AFFORDABLE HOUSING
DEVELOPMENT SSD-83256463
ARCHITECTURAL DRAWINGS
THE BOULEVARDE
PUNCHBOWL
COLLINS AND TURNER
SEPTEMBER 2025

No	Date	By	Note
B	9/12/2025	DC	For RTS

Project	
Affordable Housing Development SSD-83256463 150 The Boulevard and 34 Dudley Street Punchbowl, NSW

2 Ground Floor
1:50

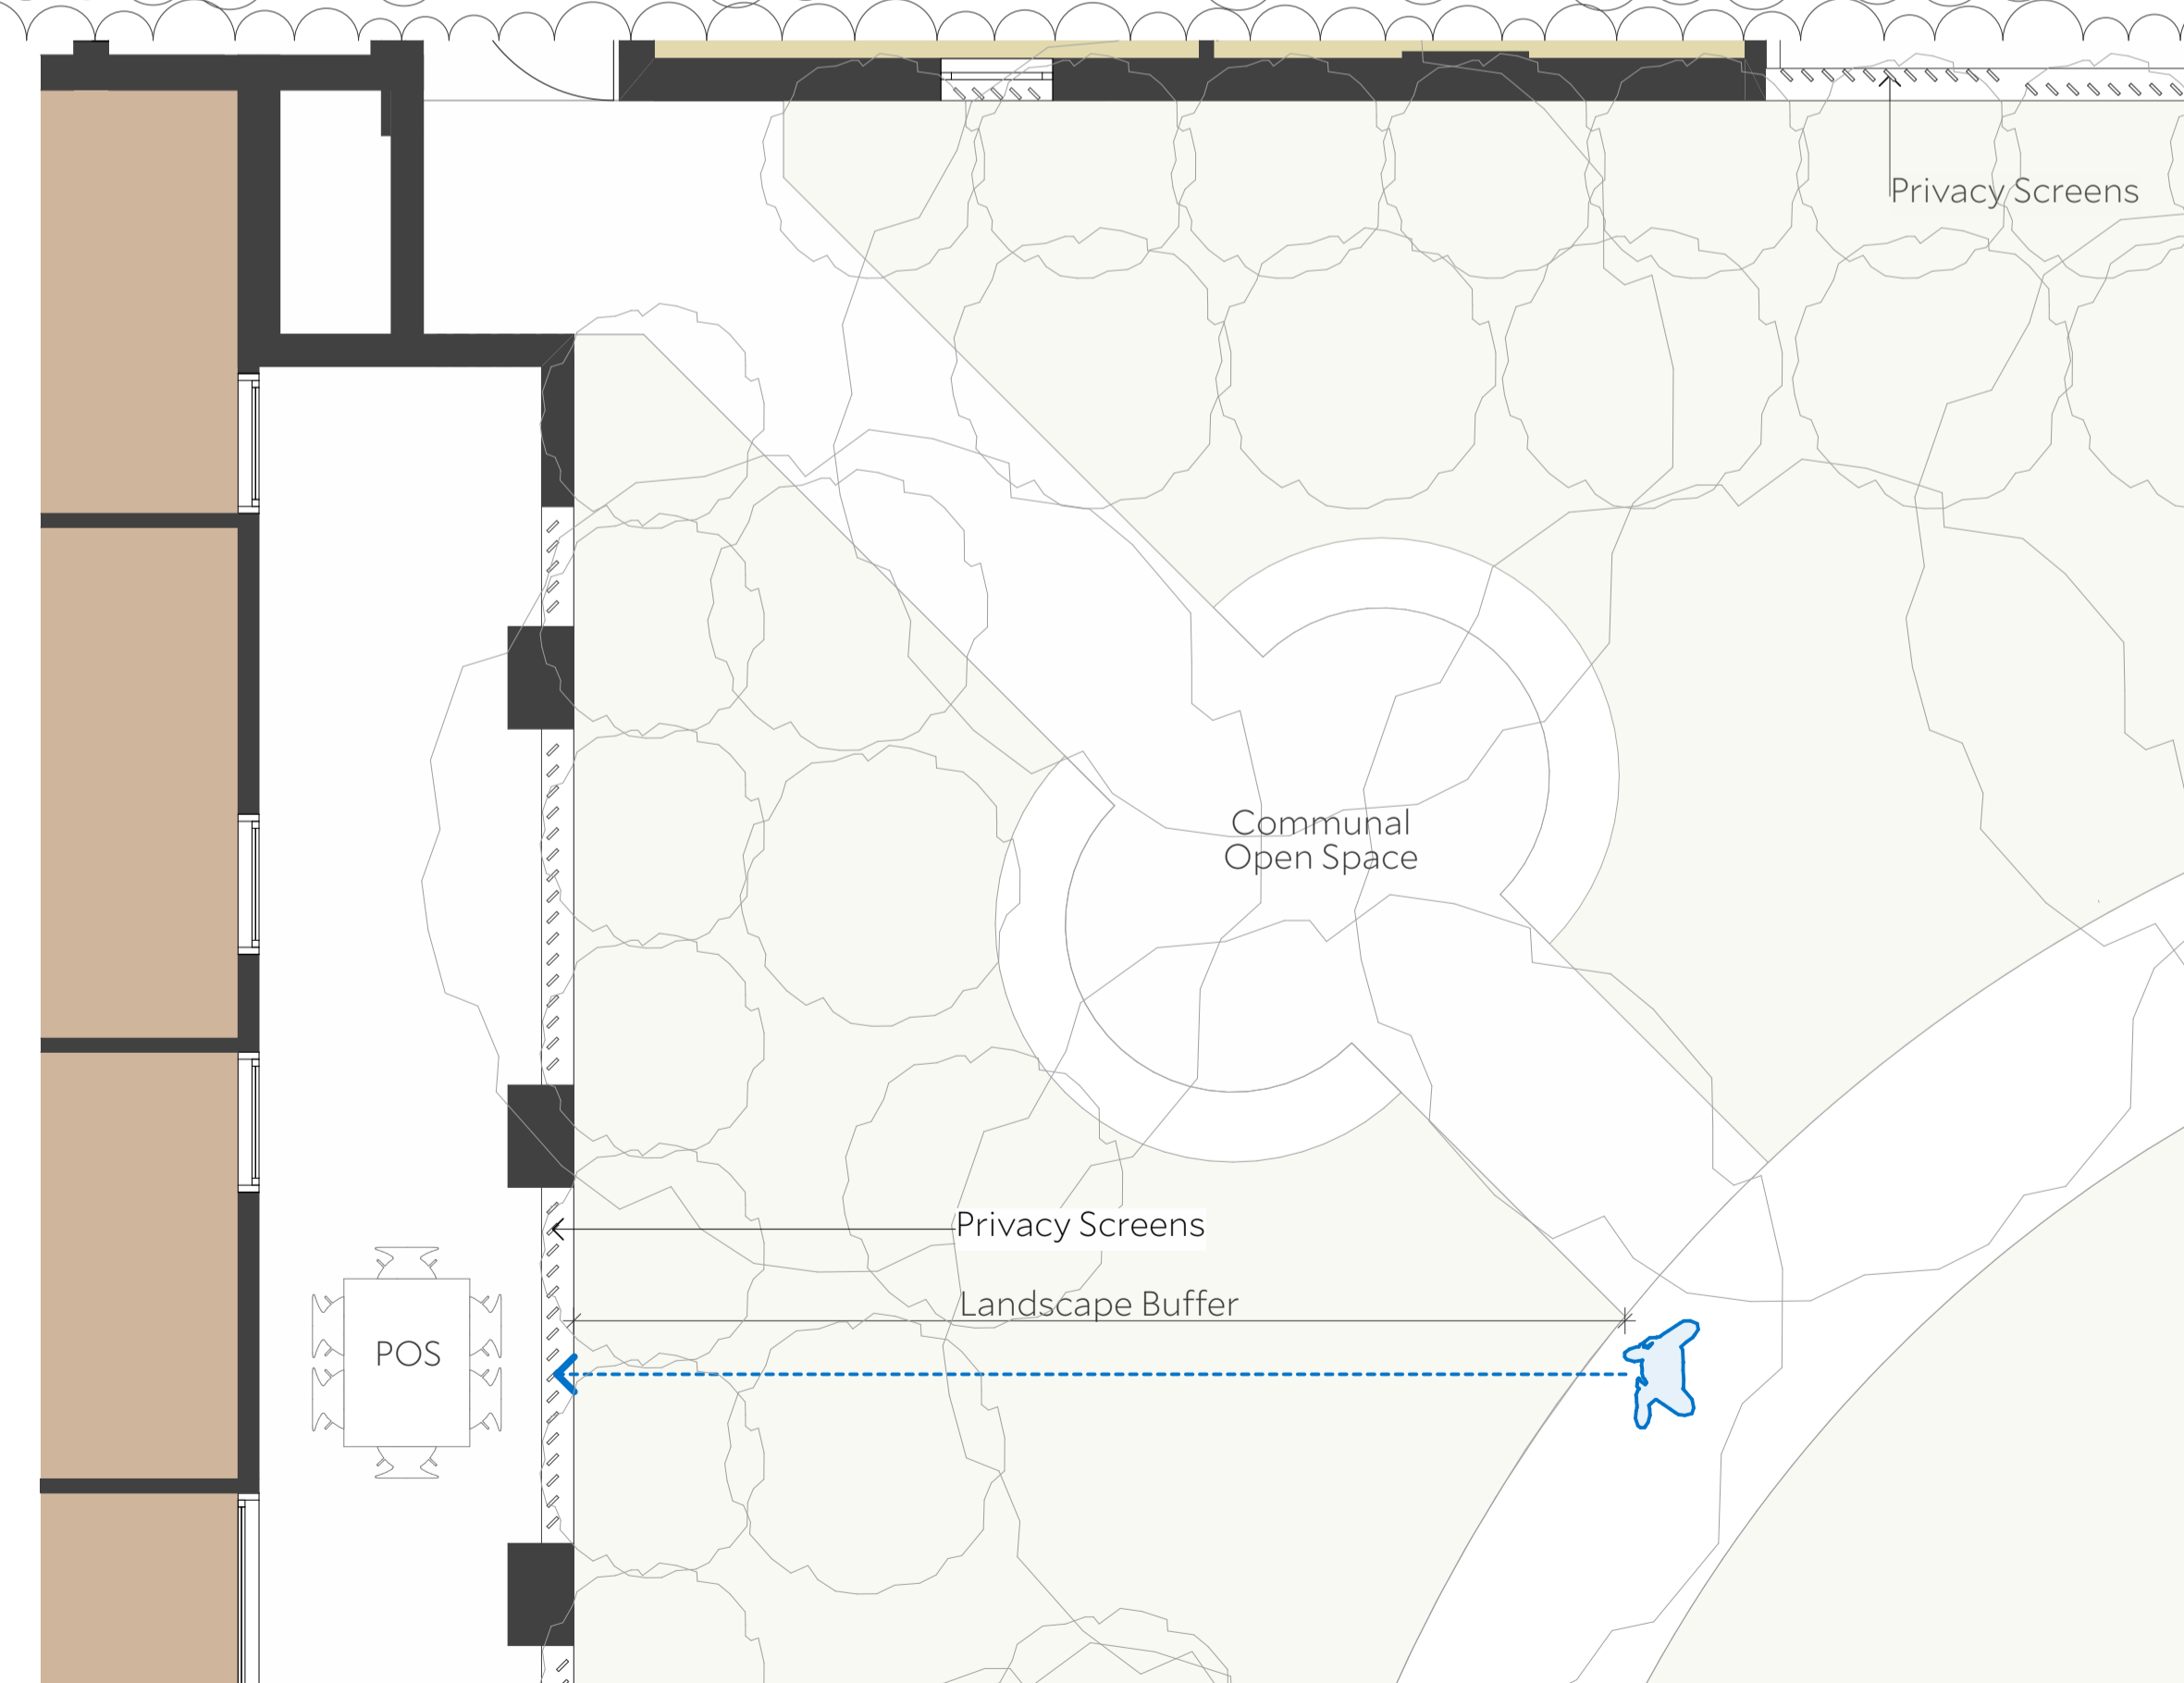
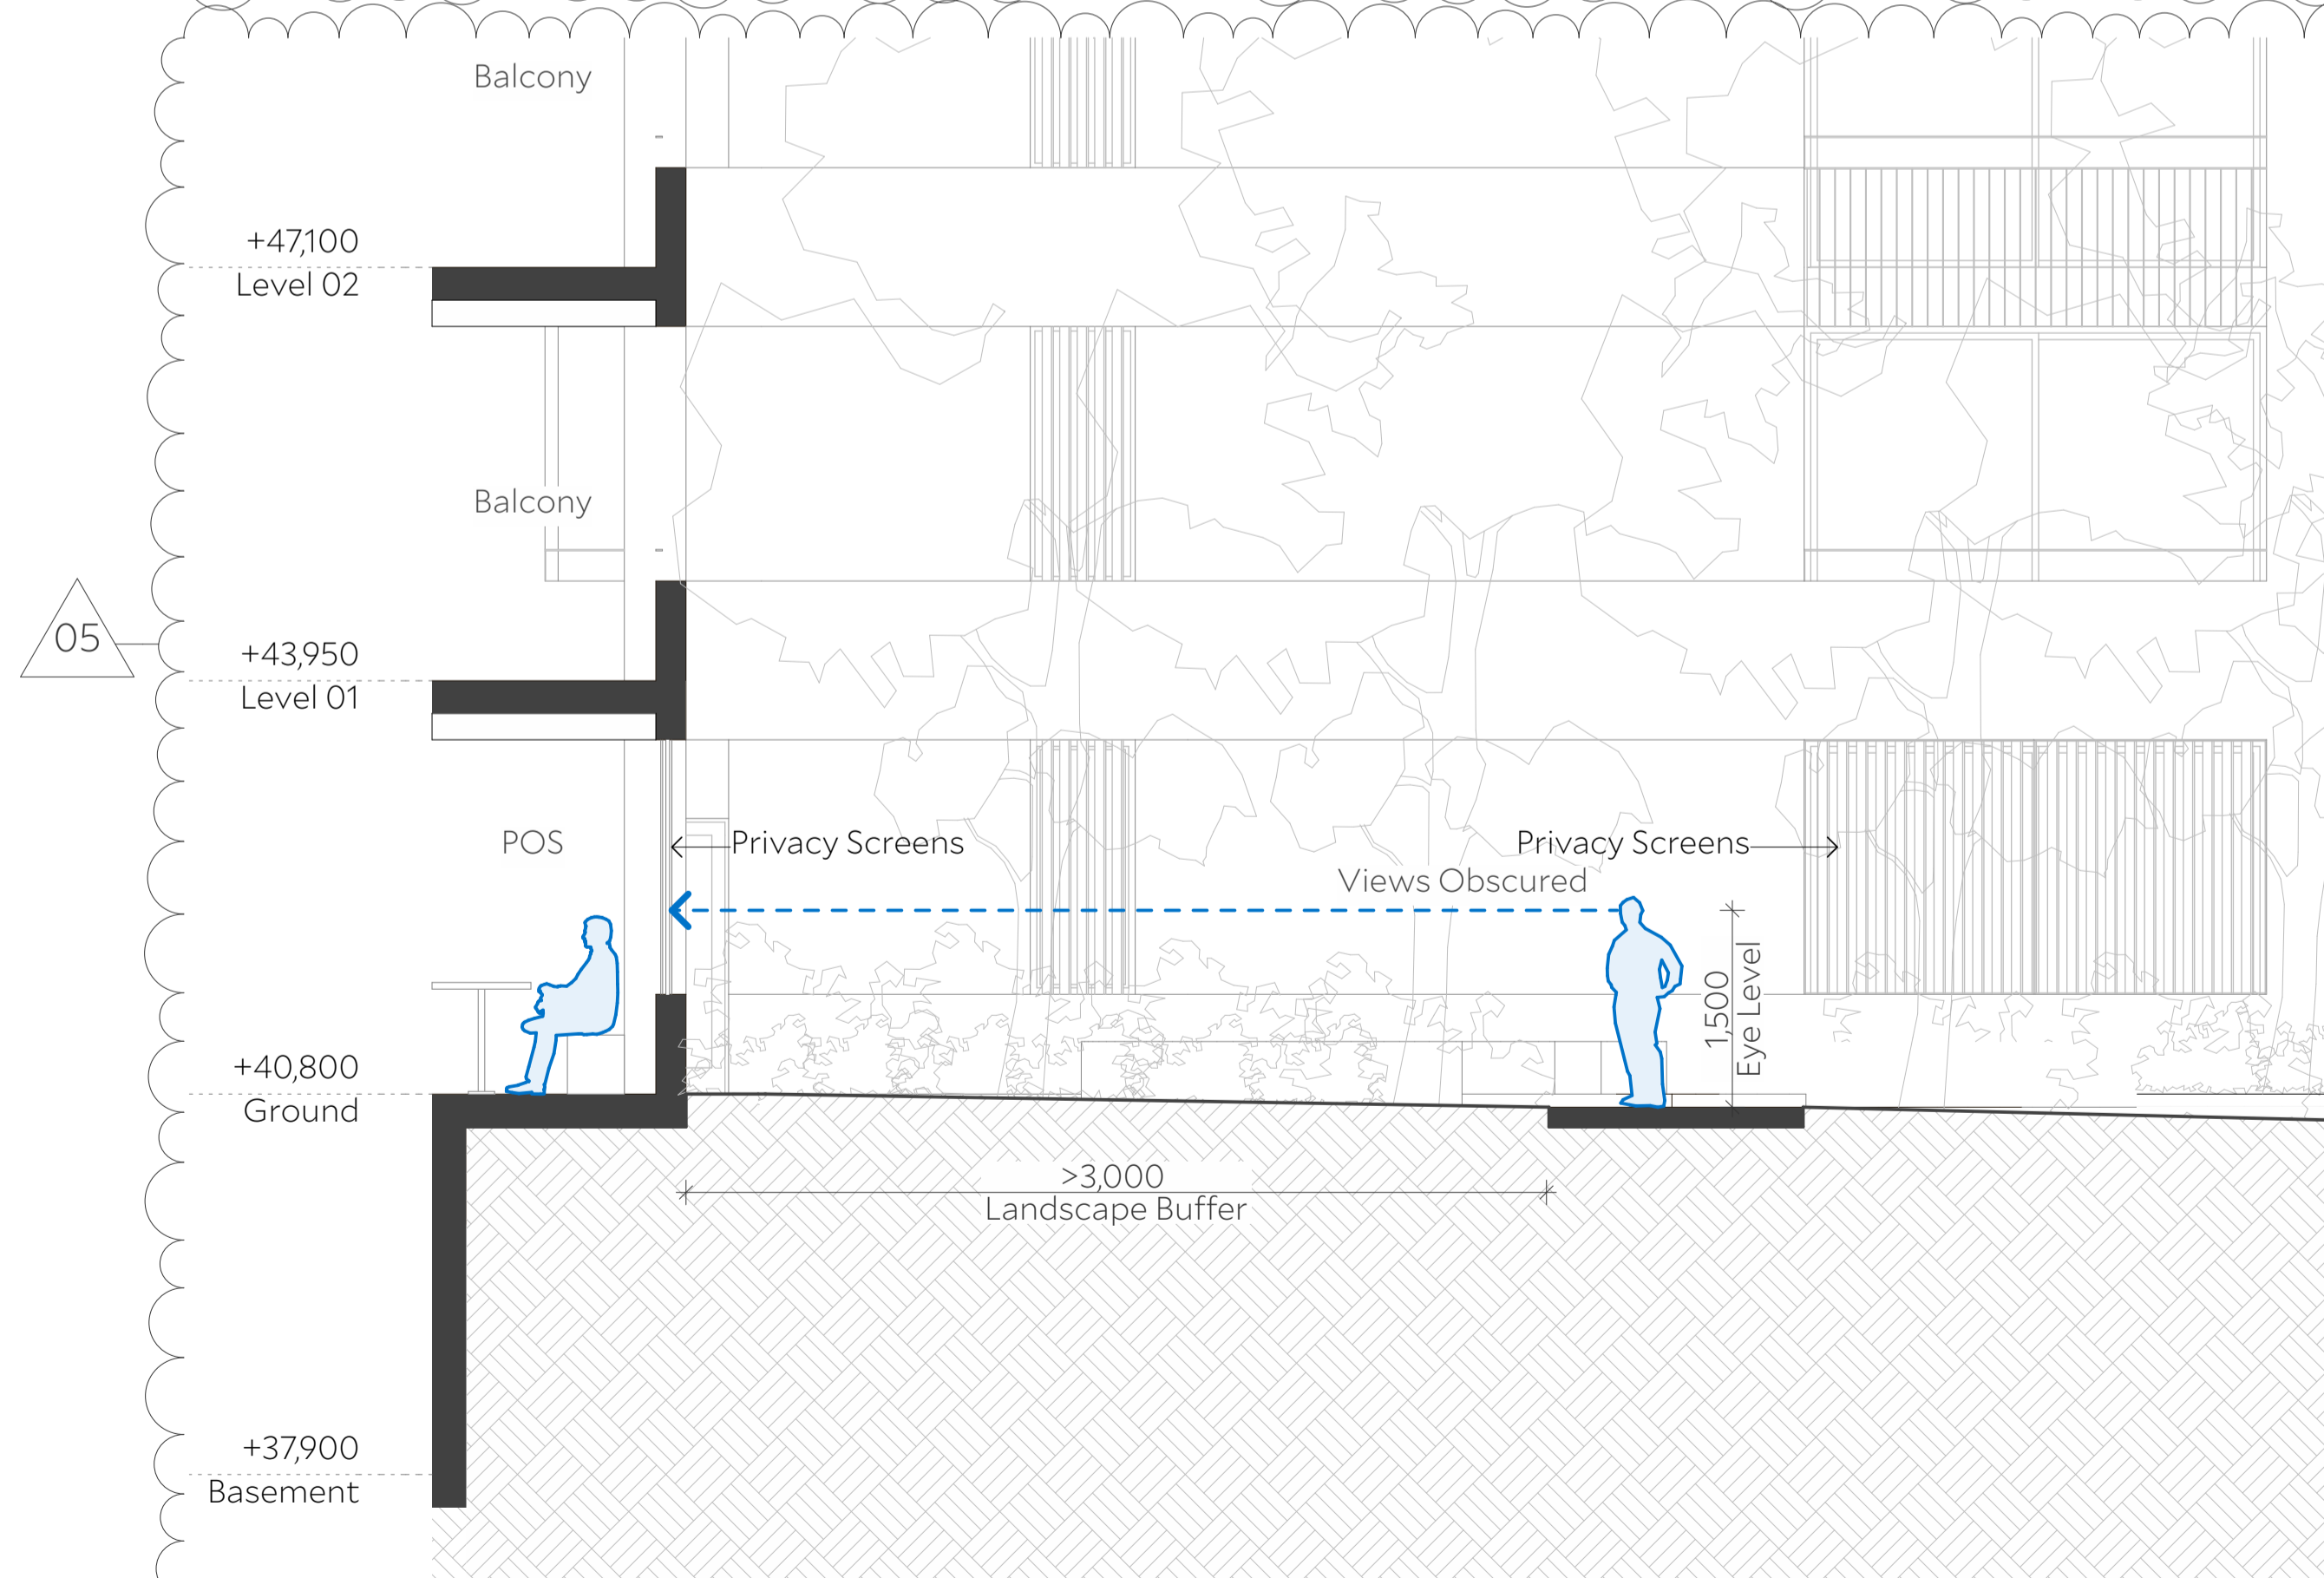
ID	Name
05	Privacy screens added and pathway repositioned Refer to RTS Item DPHI 7
06	Landscape privacy screen added Refer to RTS Item DPHI 8
